County of Fairfax, Virginia

STAFF REPORT

APPLICATION FDPA 2003-LE-025-02

PROPOSAL: Amend FDP 2003-LE-025 previously approved for residential development on 18.26 acres to permit a reduction of certain yard requirements on a single-family attached dwelling lot for construction of a screened porch 5.4 feet from the front property line.

CONCEPTUAL / FINAL
DEVELOPMENT PLAN AMENDMENT

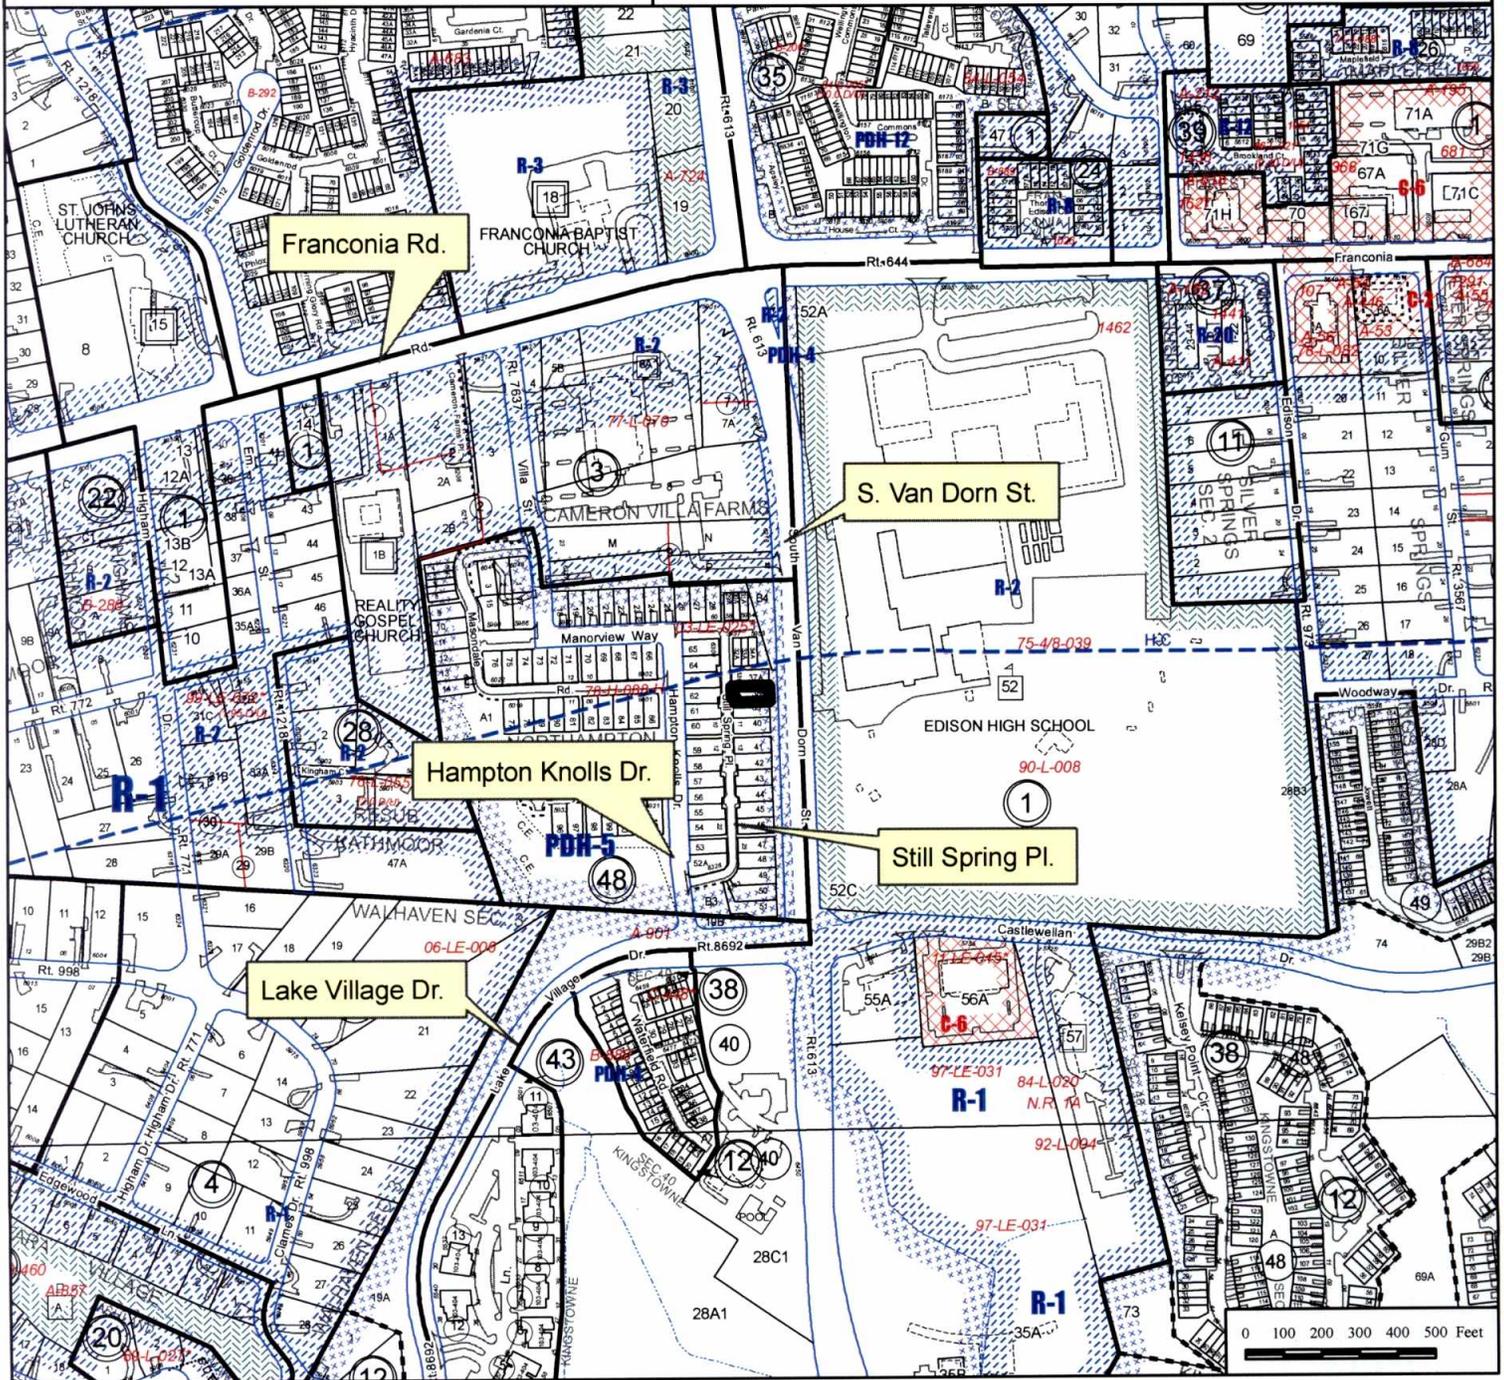
- 1. Comment:** There is an existing 2-inch caliper landscape tree located at the southeast corner of the lot that appears to have been planted as part of the landscaping and tree cover requirements for the Northampton site plan, County plan number 000623-SP-002. This landscape tree appears to be located in the area of the proposed 1-story screened porch addition and may need to be removed to accommodate construction of the proposed addition, resulting in the loss of the 150 sq. ft. of canopy claimed for this tree.

The applicant has revised the CDPA/FDPA to show the location of both the existing Bradford Pear tree and a two-inch caliper Cherry Sargent replacement tree. The applicant is proposing to plant the replacement tree in the southwestern corner of the site outside of the 15-foot wide utility easement. UFMD staff has reviewed the revised plan and stated that the issue has been adequately addressed. Therefore, staff finds this issue has been resolved.

Recommendation: The location of the existing landscape tree should be clearly shown and identified on the FDPA. If construction of the proposed addition will result in the removal of this tree, this tree should be replaced with a 2-inch caliper Category III deciduous tree to replace the 150 sq. ft. of tree cover claimed for this tree on County plan number 000623-SP-002. The proposed location of this replacement tree should also be clearly shown and identified on the FDPA.

SINGLE-FAMILY DUPLEX UNIT:

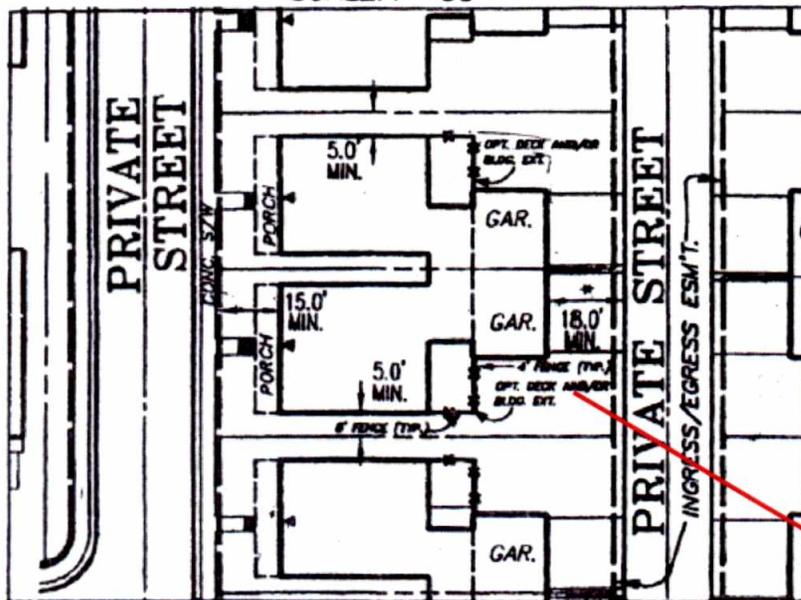
The proposed encroachment for the screened-in porch is 5.4 feet from the front property line. The Typical Lot/Unit Detail exhibit for *Single-Family Duplex Unit Type* shows an option for the addition of a deck or a building extension at the front of the single-family attached dwelling set back farther than the garage. The applicant's proposed screened-in porch would be set back at almost the same distance as the garage from the front property line. However, the steps leading to the screened-in porch are shown extending past the front wall of the garage, encroaching into the minimum required front yard. Staff believes the steps could be reconfigured so that they do not encroach into the minimum required front yard, thus increasing the distance from the front property line from 5.4 feet to 8.4 feet. A portion of the floor area currently allocated for the screened-in porch could be used for the steps so that they do not extend past the front wall of the garage. Staff believes that if the steps are relocated so that they do not encroach into the minimum required yard, this design standard would be met.
